TECHNICAL SERVICE BULLETIN

Bulletin No.: TSB-037

Subject: Oasis Manual Ball Valve

Models: All Quantum Virtual Pipeline Lite Trailers

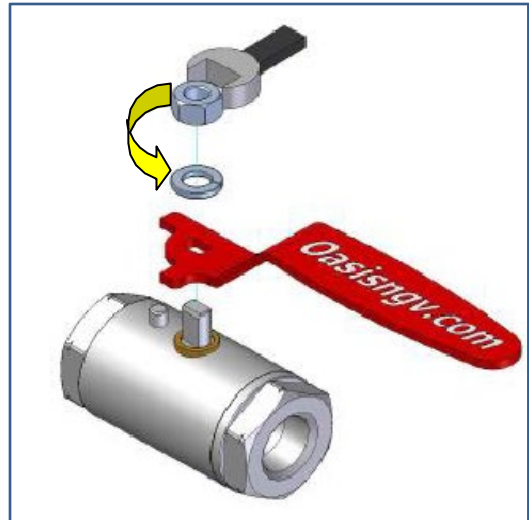
The manual shut off valves used on the Quantum VP trailers may over time become loose. During trailer use, the manual shut off valves may not remain in the position selected by the operator.

Over time the seals and packings may relax or take a set which decreases the force required to turn and actuate the valve. In some cases the force reductions is sufficient to allow the valve to move due to vibration and weight of the handle alone.

A new handle has been developed with a detent feature to lock the valve in the open position.

1. Remove and retain the nut and washer holding the handle.
2. Remove and discard the original handle assembly.

3. Verify the stem gland is still in place.
4. Place the new handle in position on the valve and place the washer and nut on the stem.
5. Tighten the handle retaining nut.
Tighten to 53 lb.in. (6 N.m.)
